NFPA 805 OBSERVATION VISIT TRIP REPORT

Location: Oconee Nuclear Station, Seneca, South Carolina

Subject: Risk-Informed, Performance-Based Fire Protection Transition Pilot-Plant Observation Visit - Oconee Nuclear Station

Figure 1. Multiple Spurious Post-Transition Inspections

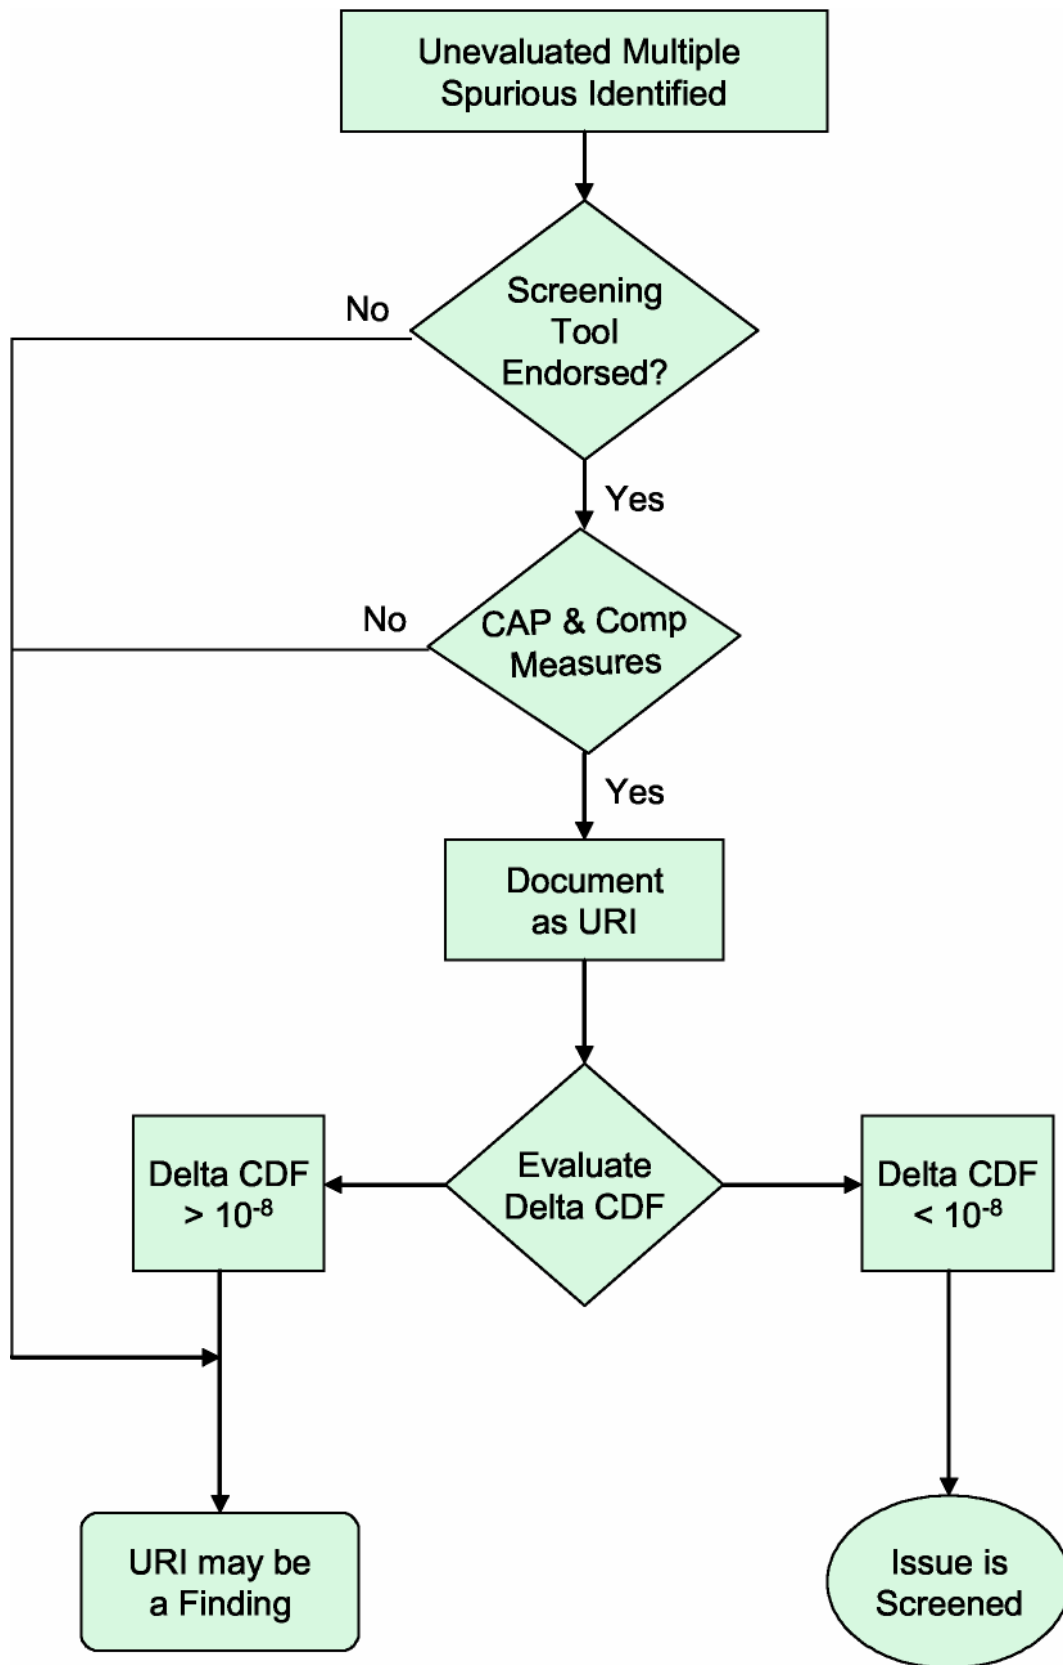
Status: OPEN. The November 2005 pilot-plant observation visit initially identified this issue. The NRC Staff reviewed the ROP relative to the treatment of newly identified multiple spurious operations that have unknown risk significance.

At the March 2006 pilot plant observation visit, the Staff presented a flow chart, illustrating how newly found multiple spurious circuits identified during an inspections, could be treated (See flow chart below). In addition to the flowchart, the following information was discussed:

Resolution Action(s)/Action Party: OPEN. Industry and pilot-plant participants agreed to review the flowchart, IMC 0612 questions, screening thresholds and provide feedback to the NRC at the next observation meeting. The industry may also submit an FAQ on the issue.
